DA2025/0077

DA SUBMISSION – 10-28 LAWRENCE STREET, FRESHWATER

This objection has been prepared in relation to the Development Application DA2025/0077. It has been prepared by the owners of 2-16,7,15 Undercliff Road, Freshwater, NSW 2096.

Mark up - First Floor Plan

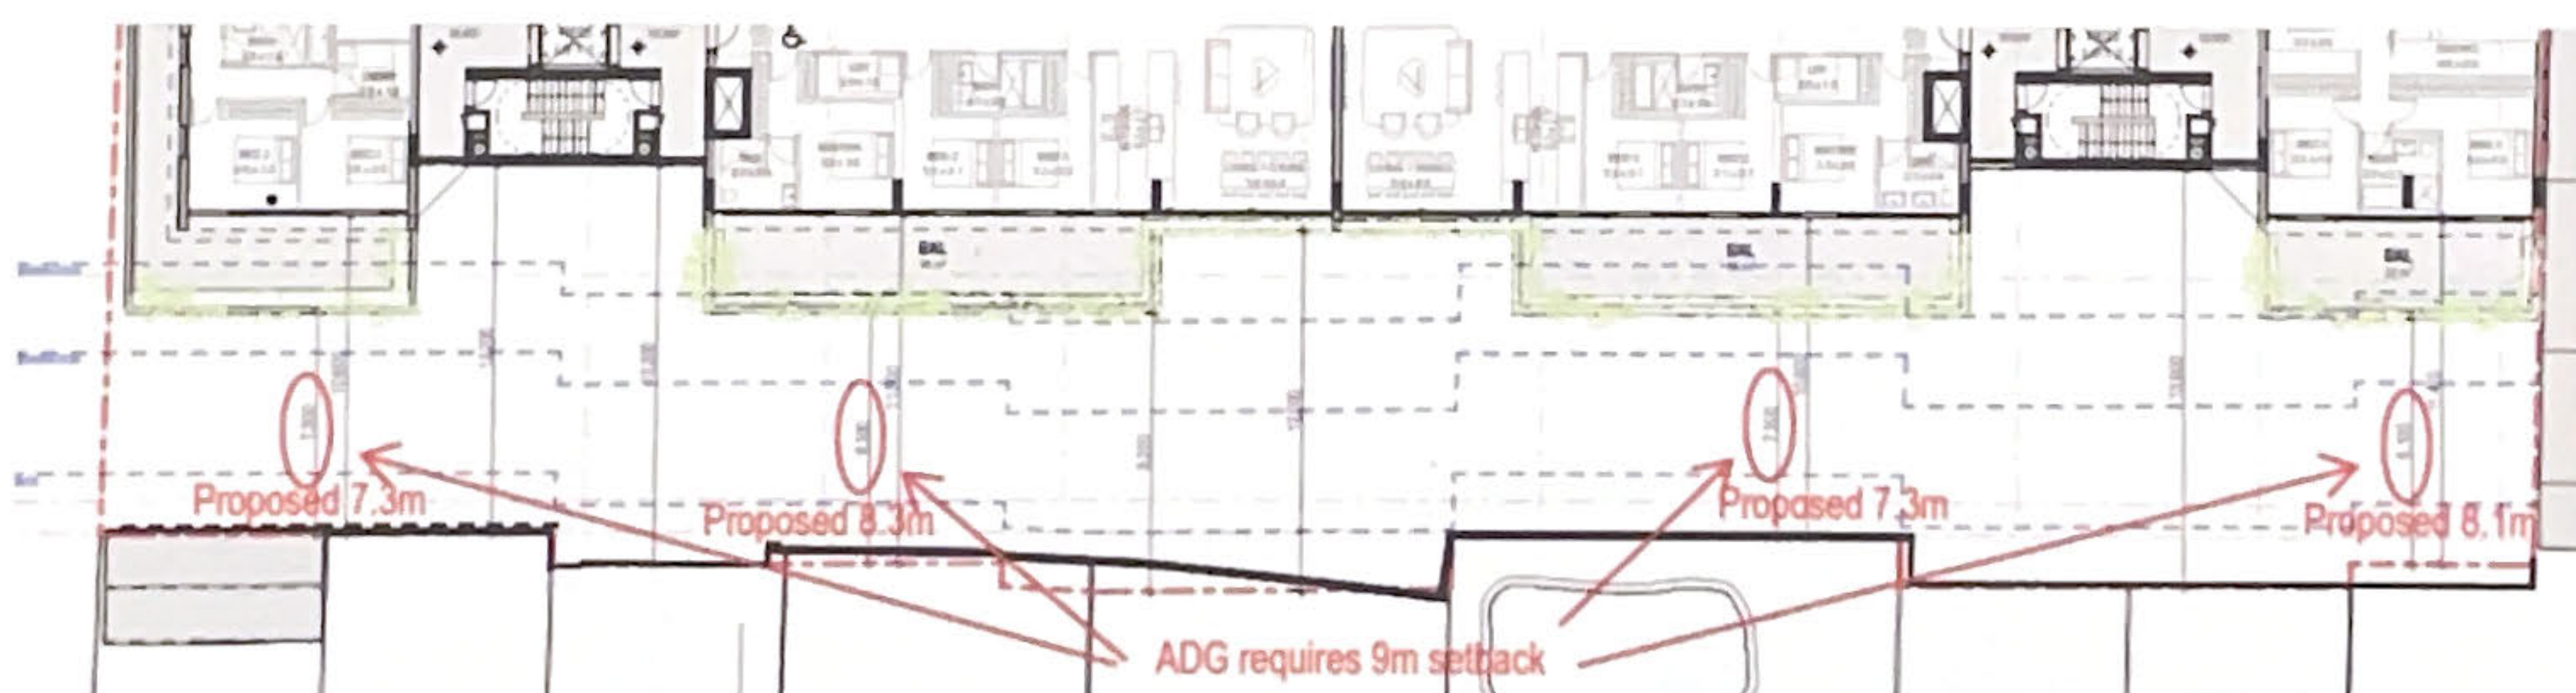
The proposed development does not comply along the southern boundary as outlined below:

Full compliance with the ADG should be required to ensure sufficient physical separation at the interface with the Low density zone. There is no reason why the development cannot comply. Privacy screens will not resolve acoustic impacts from the close proximity.

The variations to the separation requirements of the ADG will result in adverse impacts in relation to visual and acoustic amenity to the dwellings to the south.

In addition, the design appears to breach the ADG setback guidelines to the rear of numbers 4, 8 and 12 Undercliff, which are already closer to the development due to the shape of their blocks – the design needs to be updated to take this into account and move the setbacks to be the minimum 9m recommended by the ADG.

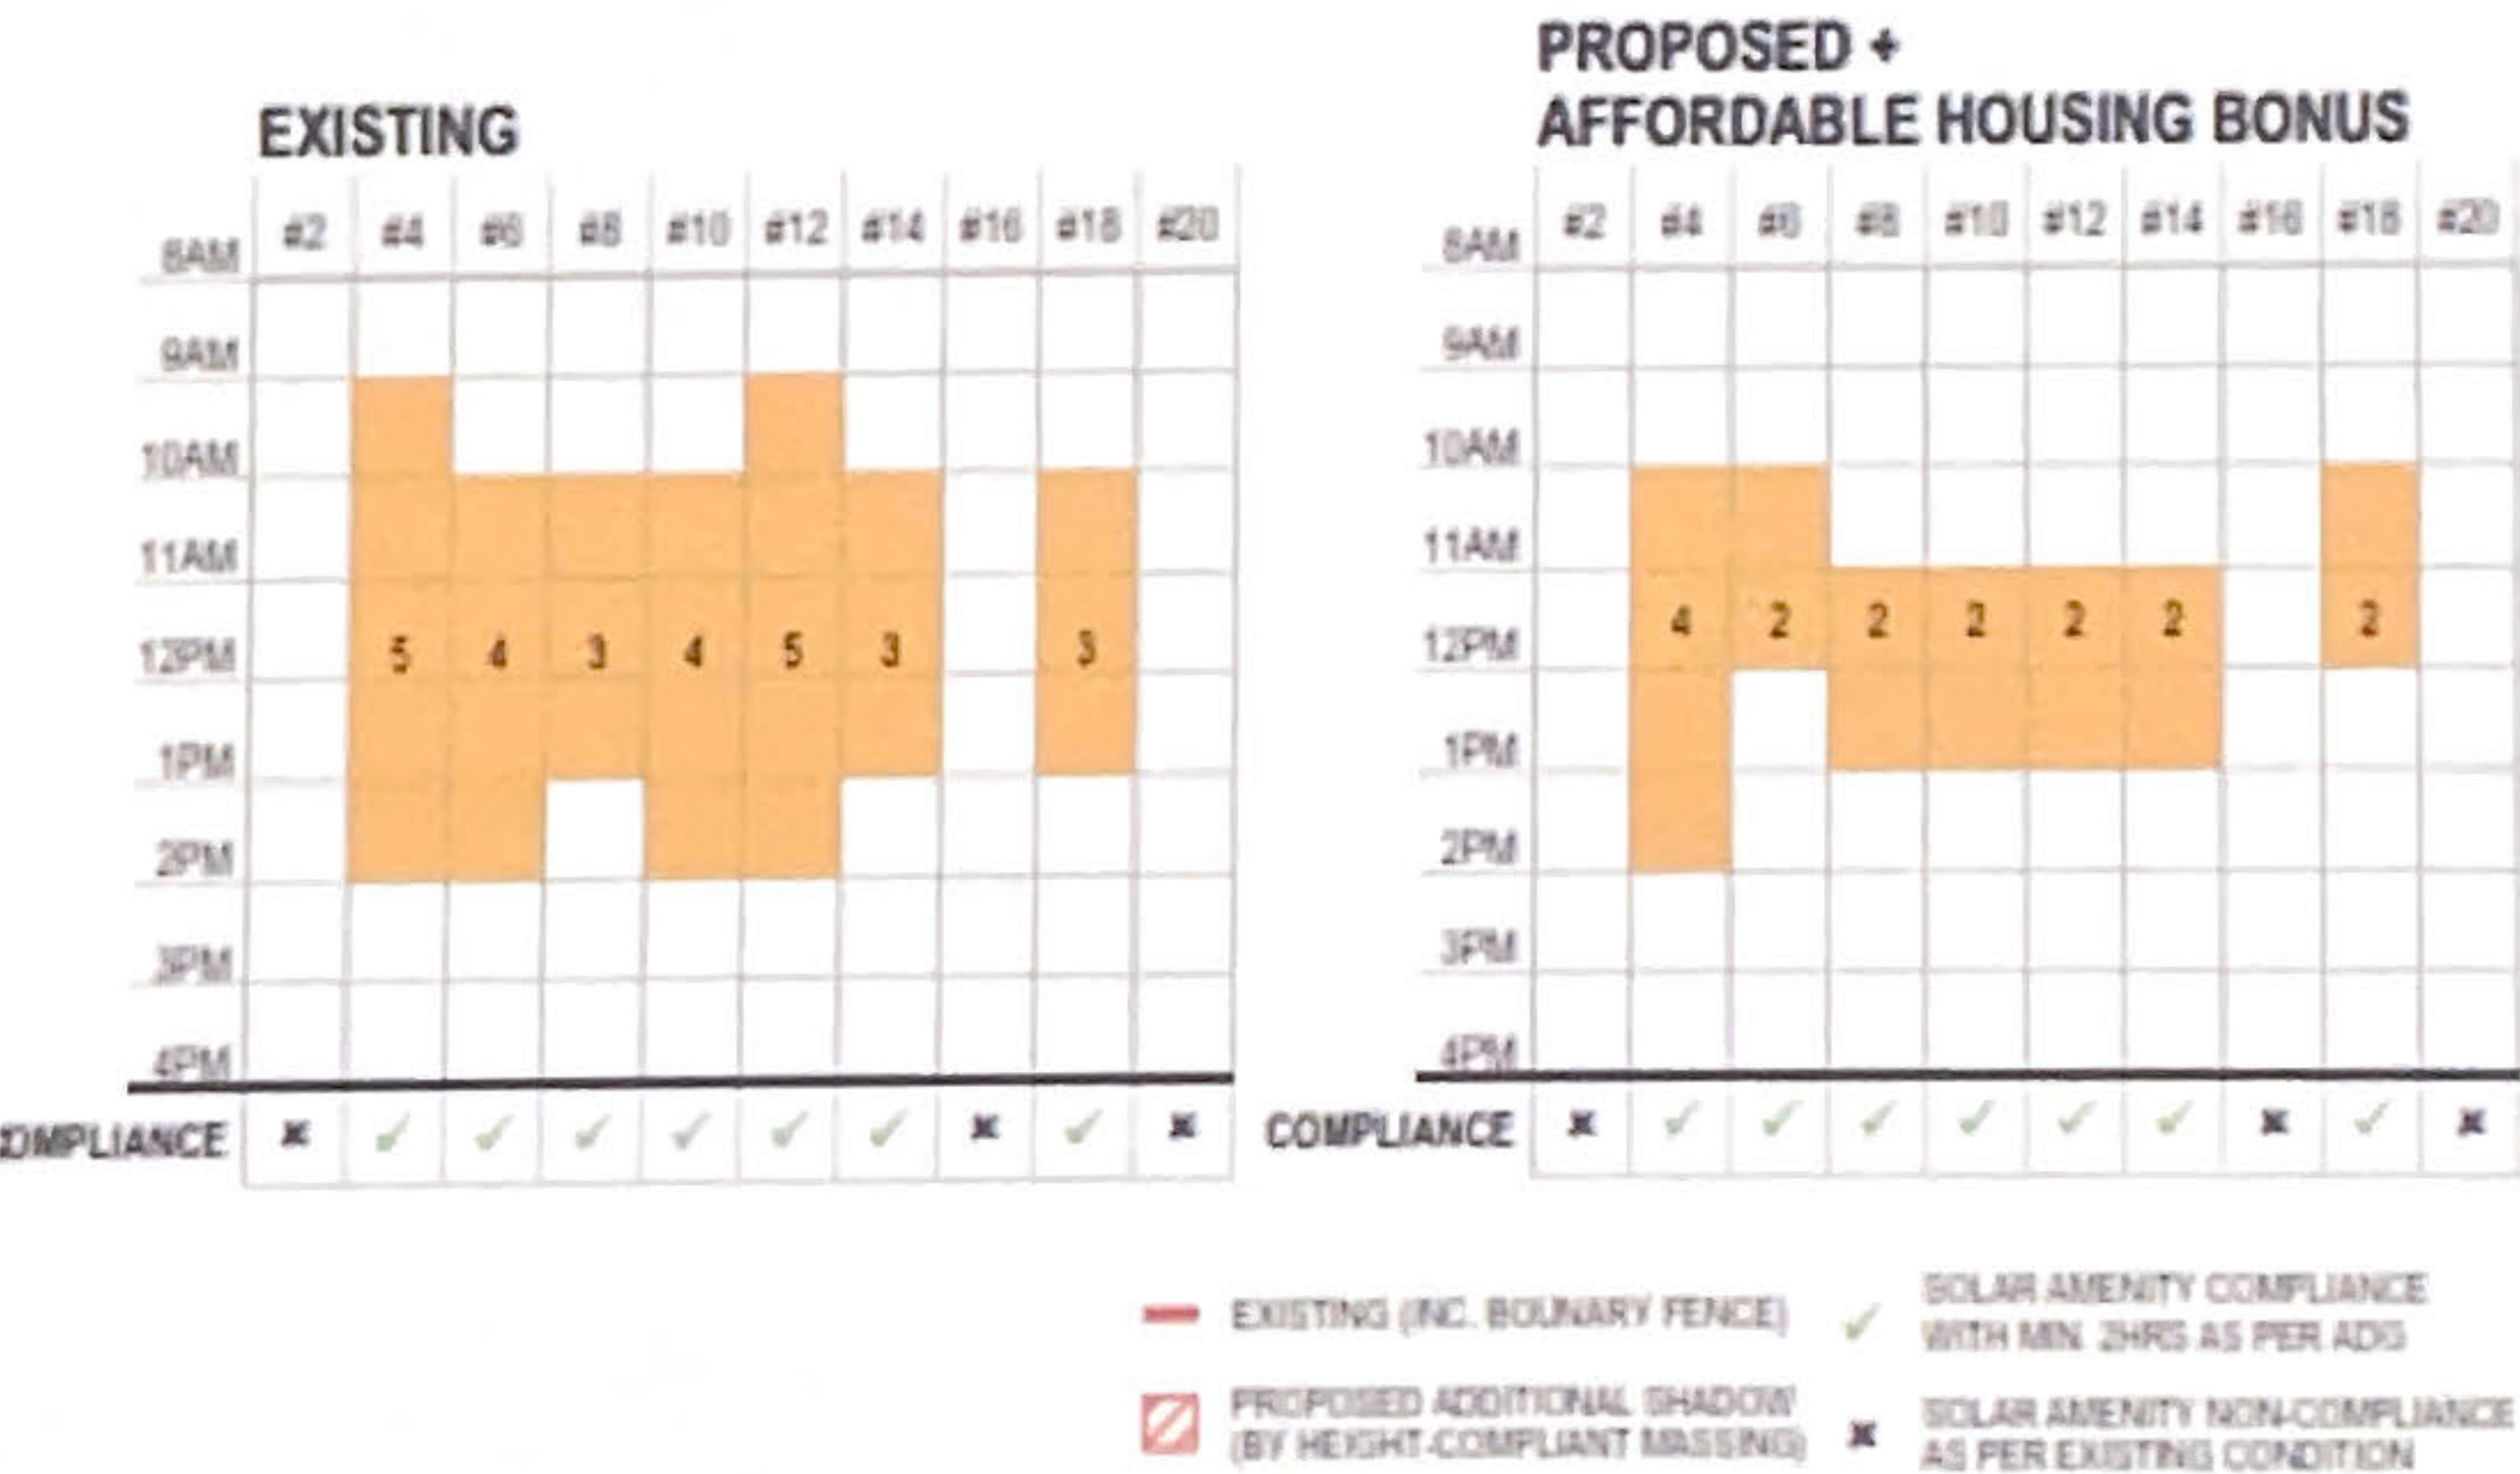
The Warringah DCP requires 72 retail parking spaces.

The development provides 62 spaces, 10 spaces short. In addition, the proposal requires two on-street parking spaces to be subsumed into an on-street loading dock, creating a total shortfall of 12 parking spaces. The use of an on-street loading dock for goods inwards and rubbish removal is itself not in line with council guidelines.
